F/YR20/0824/F

Demolition of rear annexe and workshop and alterations and refurbishment of existing dwelling to form a 4-bed dwelling

F/YR20/0854/F

Erect 3 x 2-storey dwellings comprising of 1 x 3-bed and 2 x 2-bed involving demolition of existing building within a Conservation Area

Date	Scale	Dwn	Dwg. No.	Rev.
June.2020	1:100/250	PD/CB	P02

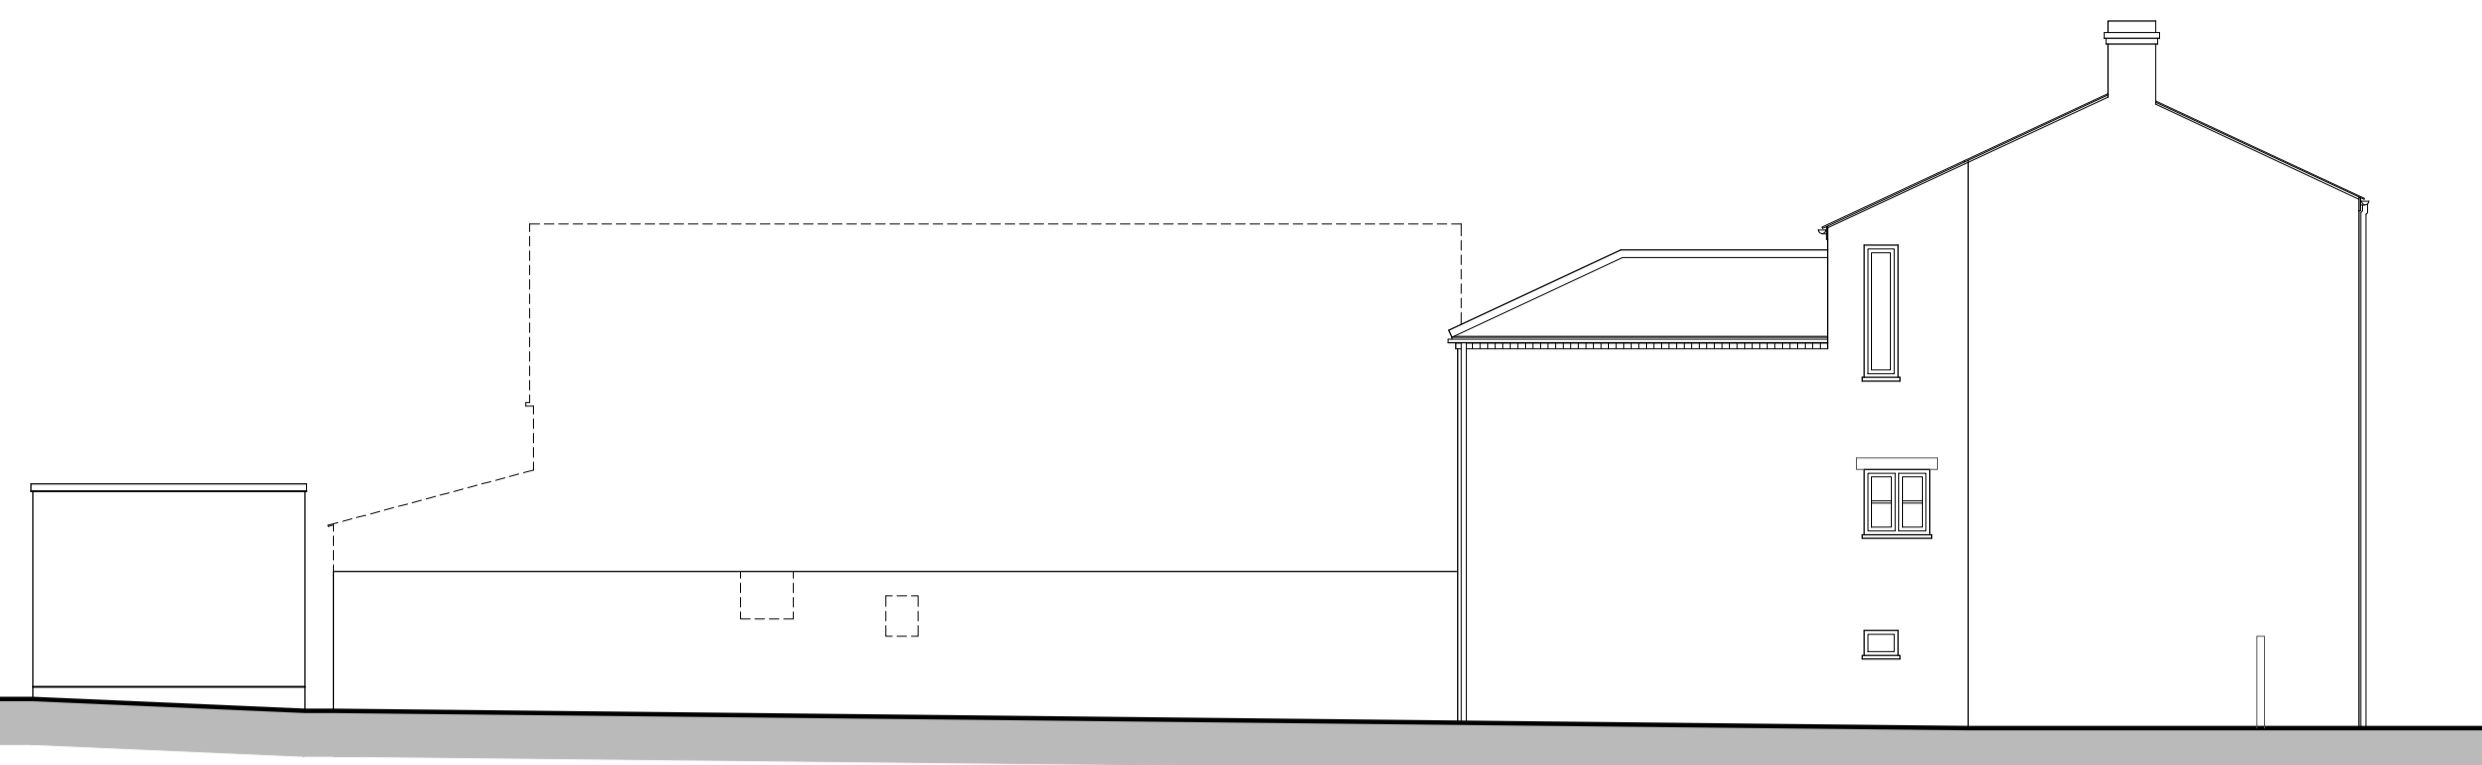
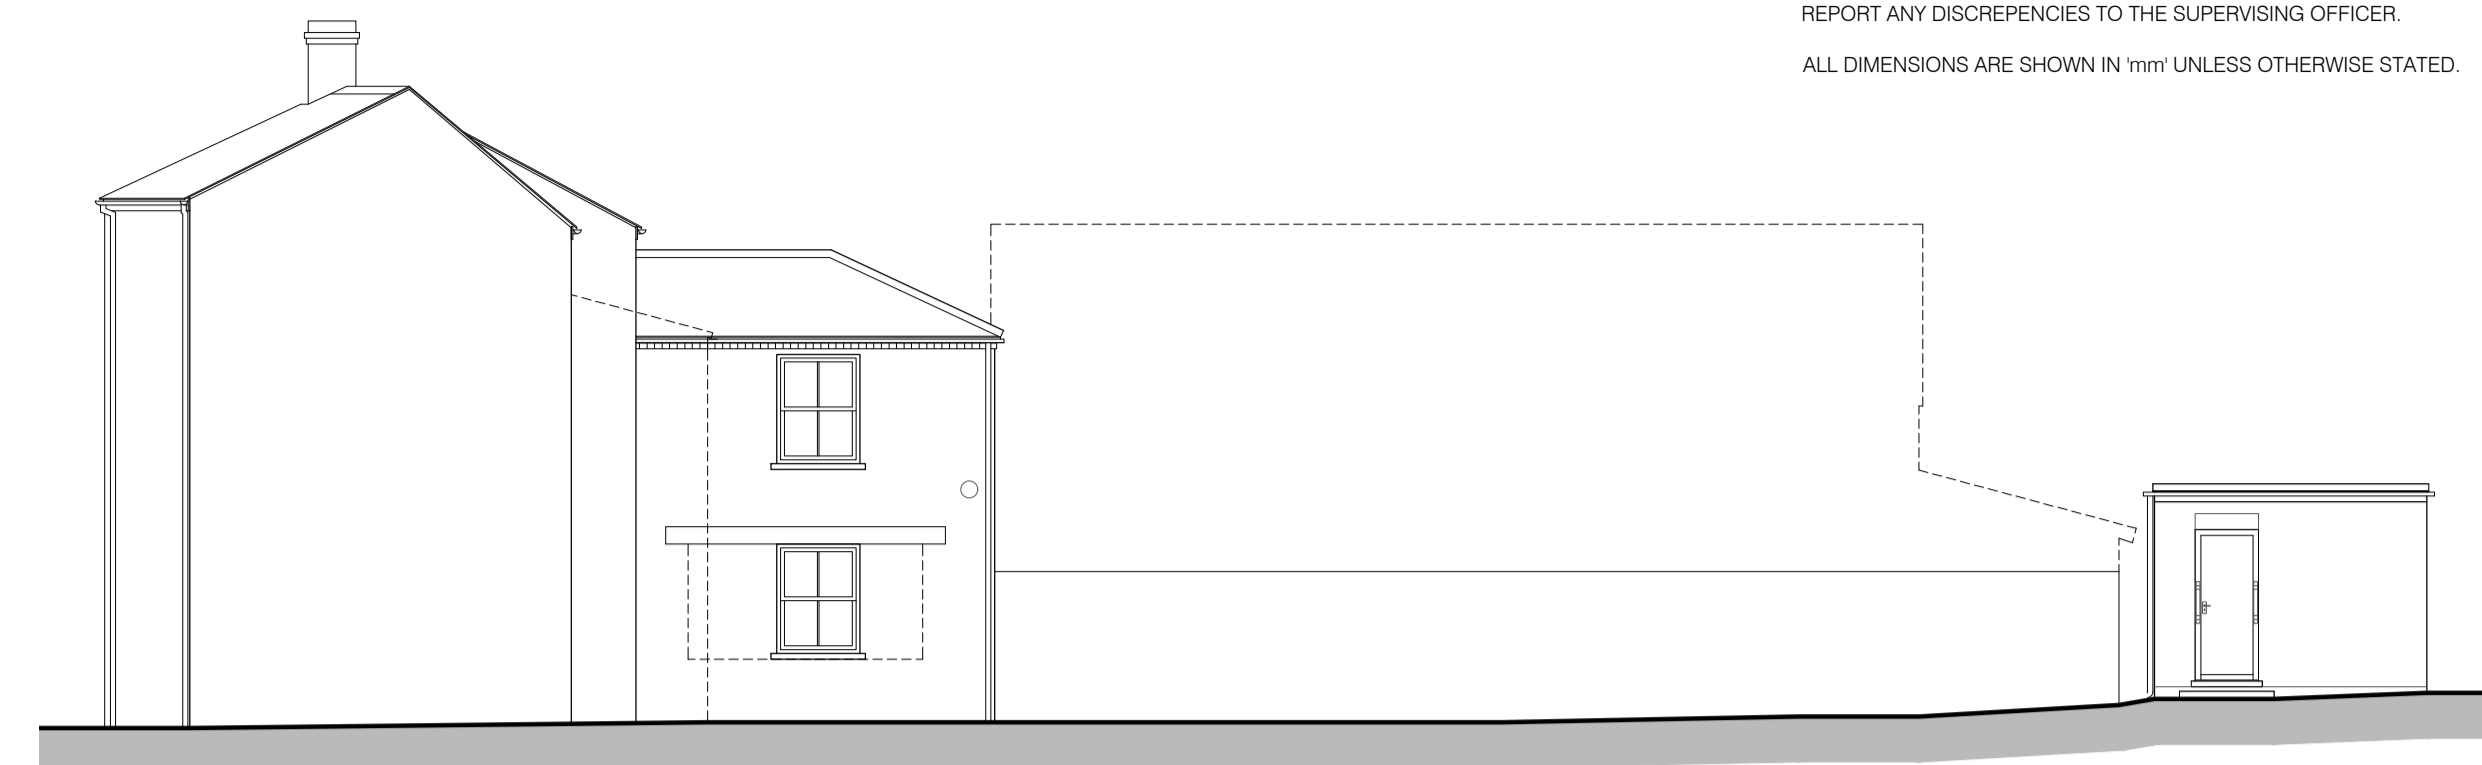
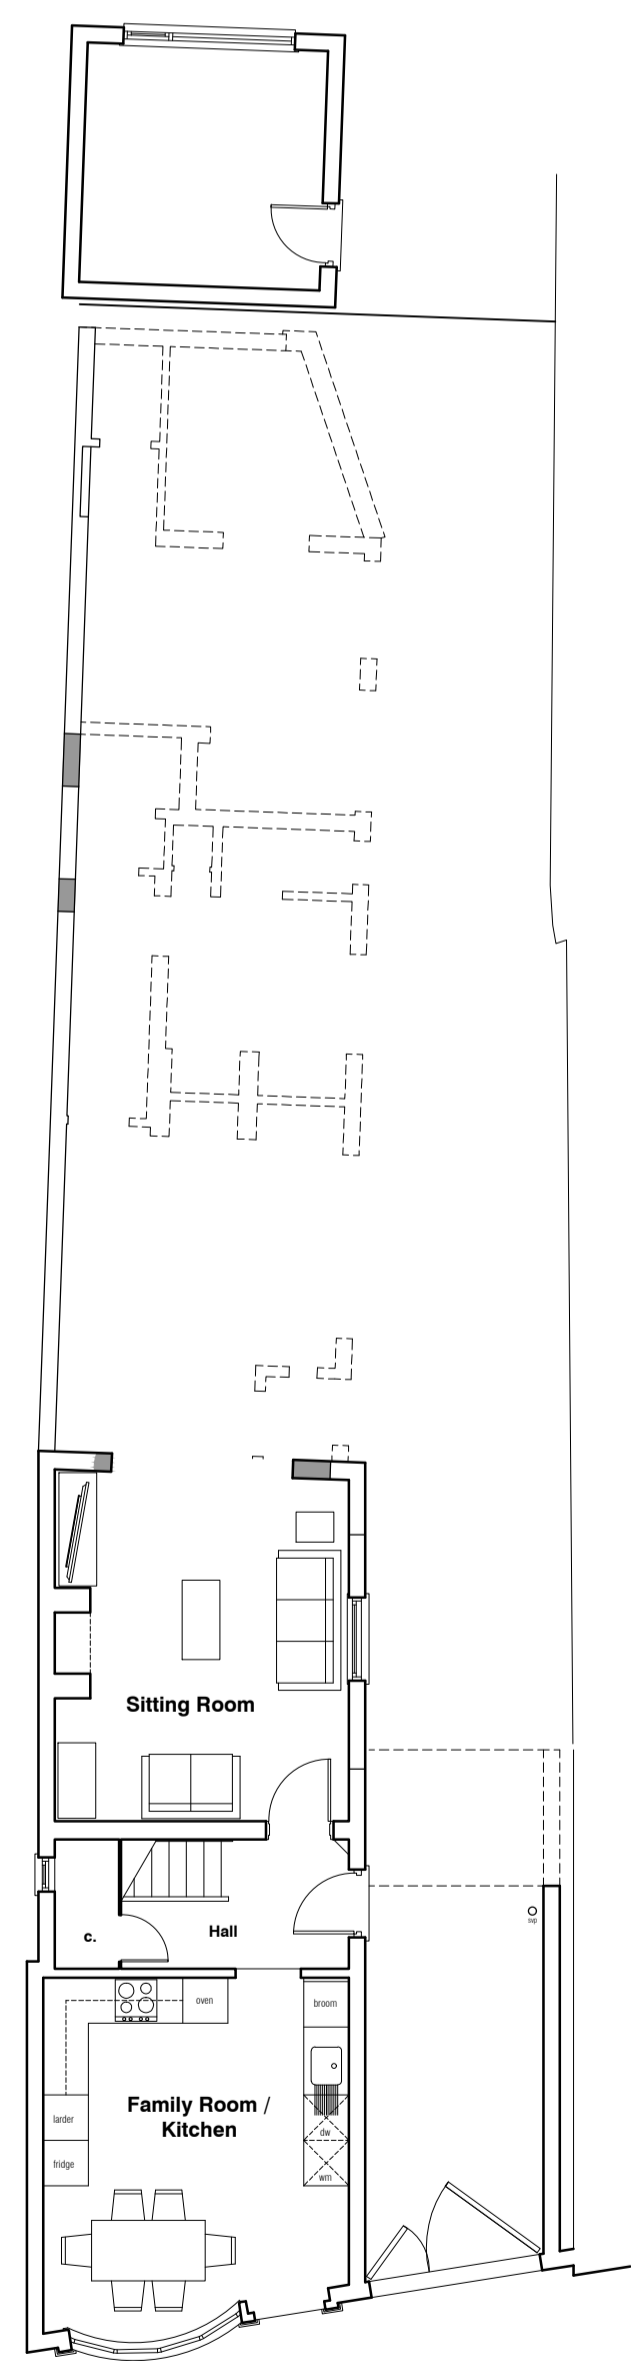
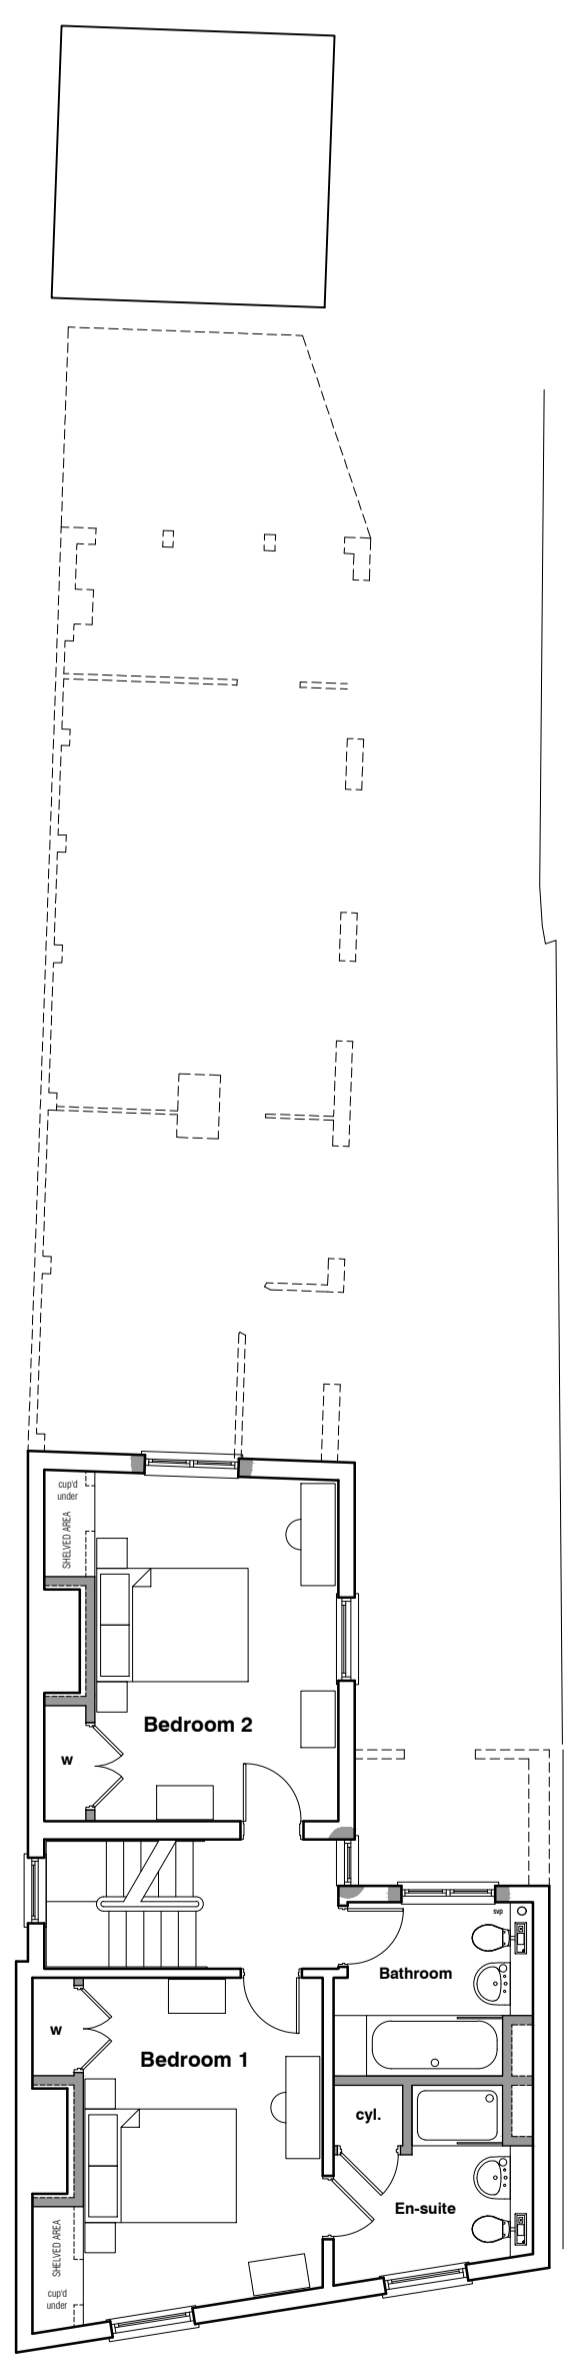
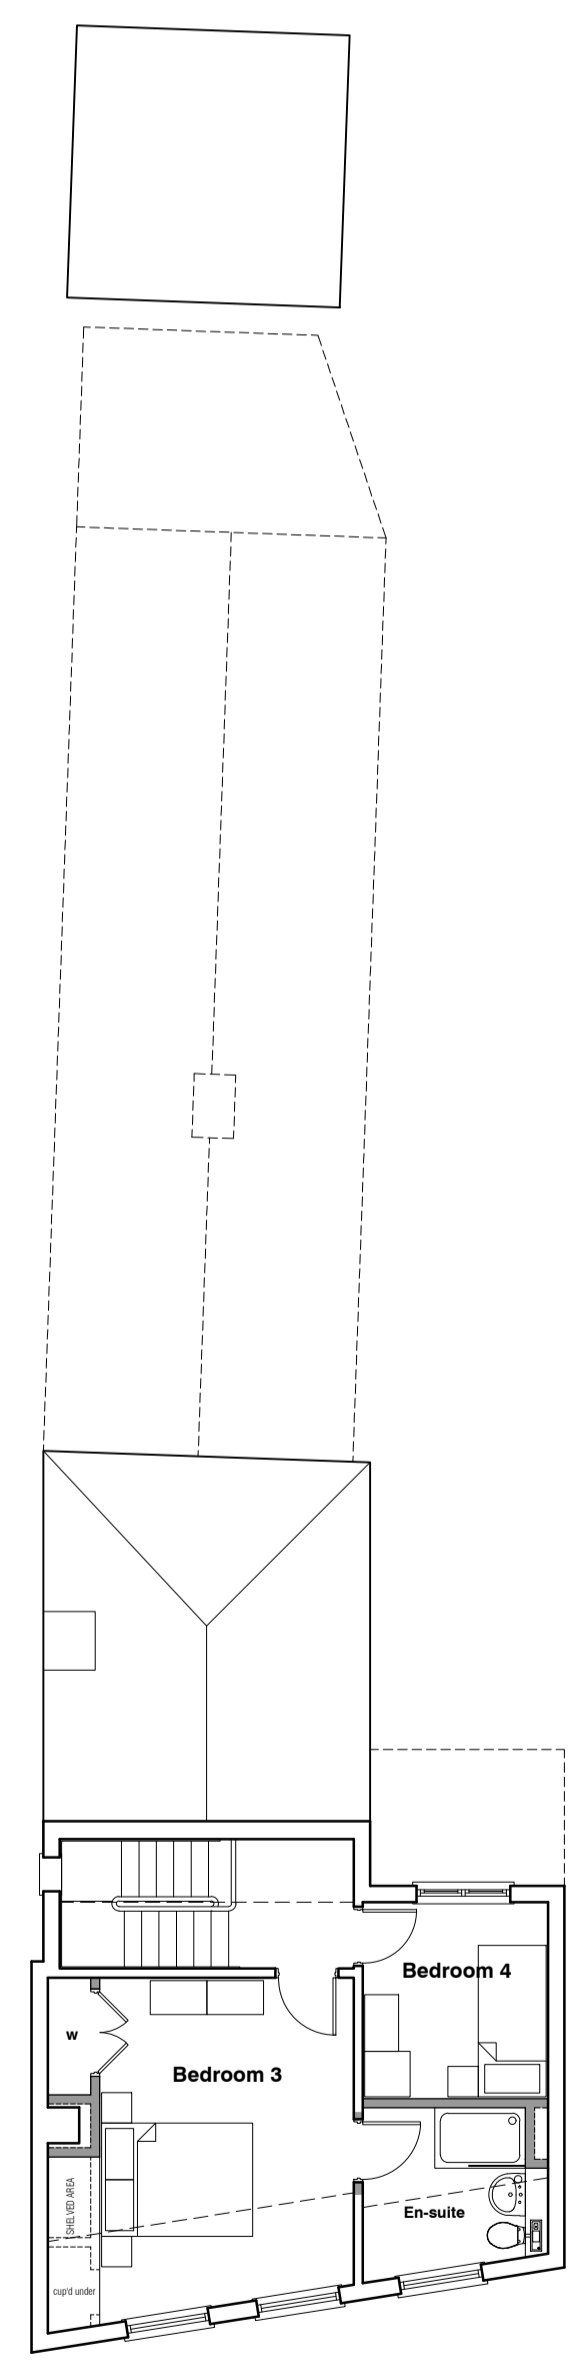
- 9.12 The replacement of all joinery to the front elevation with multi-paned sashes, which may appear to be more in keeping, but does not take into account the loss of historic fabric, including glazing. The application also proposes to reinstate a doorway (which would be acceptable) and to introduce a conjectural mullion and transom glazing bar arrangement, again without consideration for the historic value of the existing shop front. It is not clear from the application which material the proposed windows will be.

- 9.13 The removal of the first floor extension over the archway, which appears to be a circa 1960s element and therefore does not contribute significantly to the overall interest of the property would however be acceptable.

- 9.14 The proposal also seeks to demolish the entirety of the workshop element and conservatory, whilst retaining the modern office to the rear (which falls outside both application sites) and reinstate the large workshop window with coloured glass lights to both top and bottom with a standard window opening in what will become a sitting room. The justification given is that the annexe is beyond economic viable repair, though no evidence has been submitted in support of this statement; and that it is structurally unsound, but again no structural report has been submitted in support of this. The 2017 pre-app included the conversion of the workshop into a separate residence.

- 9.15 The proposed layout suggests a kitchen and family room to the street frontage with the bow window. This may prove impractical without some form of screening which will impair natural daylight into the room. A similar residential conversion within a shop front space at Market Hill was recommended to seek amendments to the scheme due to the intention to use frosted glass in order to create privacy for the occupants. Comments to that application stated that obscure glazing would create a blank face to the conservation area to the detriment of its character, the setting of nearby listed buildings and on the overall architectural quality of the building by changing its use from commercial space with an outlook to the town, to private residential (reference F/YR20/0015/F and F/YR20/0016/LB). The proposal also seeks to install bathrooms to the front elevations at both first and second floor, which would also presumably give rise to the need for obscure glazing. The proposed changes to the fenestration details to the front of No 16 would appear incongruous in the street scene and detrimental to the character and appearance of the building, conservation area and the street scene.
